ORIGINATION FORM

Proposed Revisions to a Standard Plans Index
(Please provide all information — Incomplete forms will be returned)

Index Number: 649-020
Sheet Number (s): 3 of 6
Index Title: STEEL CCTV POLE

STEEL CCTV POLE

SECTION A-A

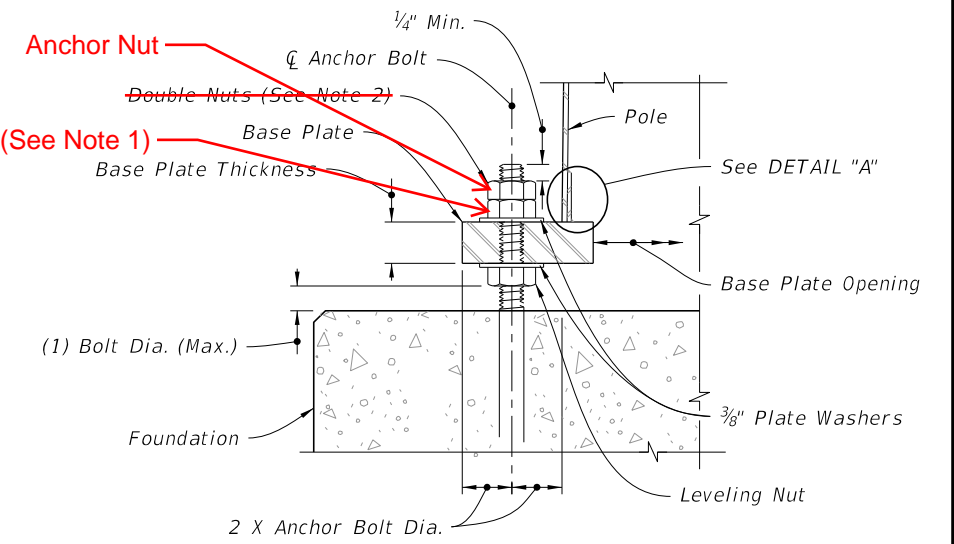
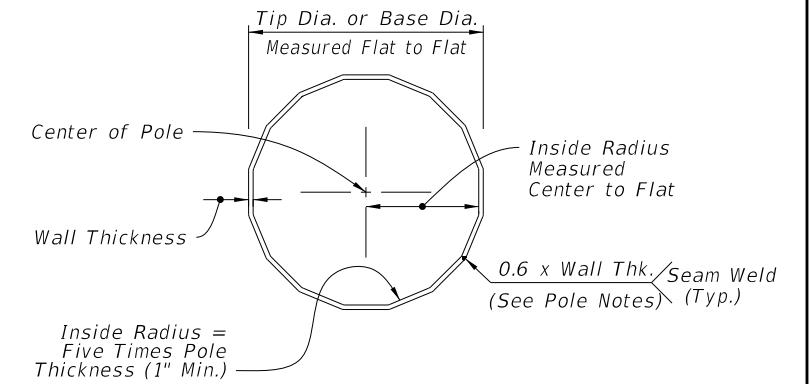
Sheet 3: Changed Note 2 and revised Section A-A to add clarity to anchor bolt nuts.

Sheet 3: These changes were to add clarity, consistency, and specificity to the anchor bolt nuts.

1. Shaft Length is based on 1'-0" height above the finished grade.
2. Retainer nut may be half-height. Provide individual nut covers (not shown) for each bolt.
3. Conduit and CSL Tubes not shown for clarity.
4. Work these details with Data Table on Sheet 2.
